Product / Process Change Notification (PCN)

PCN #:	PCN_ConDCPJ_20190624	Change Category:	<input type="checkbox"/> Equipment / Location
Affected Series:	WE-ConMJ 694102304002 - 694103304002		<input type="checkbox"/> General Data
PCN Date:	March 24, 2019		<input type="checkbox"/> Material
Effective Date:	June 24, 2019		<input type="checkbox"/> Process
			<input type="checkbox"/> Product Design
			<input checked="" type="checkbox"/> Shipping / Packaging
			<input type="checkbox"/> Supplier

DETAIL OF CHANGE:

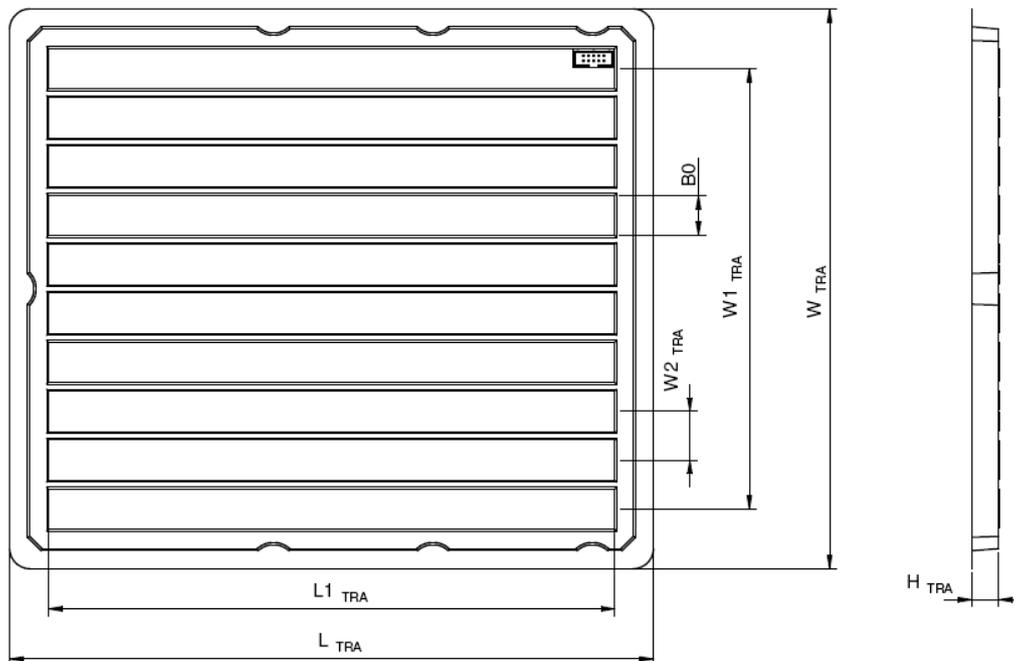
For improved transportation and handling safety, Würth Elektronik will change the packaging by implementing a new tray design. The new trays will be formed with thinner tray cavities.

BEFORE

P/N	L tra	L1 tra	W tra	W1 tra	W2 tra	B0	H tra
694102304002	167	143	217	180	20,0	15,6	9,8
694103304002	167	143	217	180	20,0	15,6	9,8

AFTER

P/N	L tra	L1 tra	W tra	W1 tra	W2 tra	B0	H tra
694102304002	167	145	217	180	20,0	12,7	9,8
694103304002	167	145	217	180	20,0	12,7	9,8
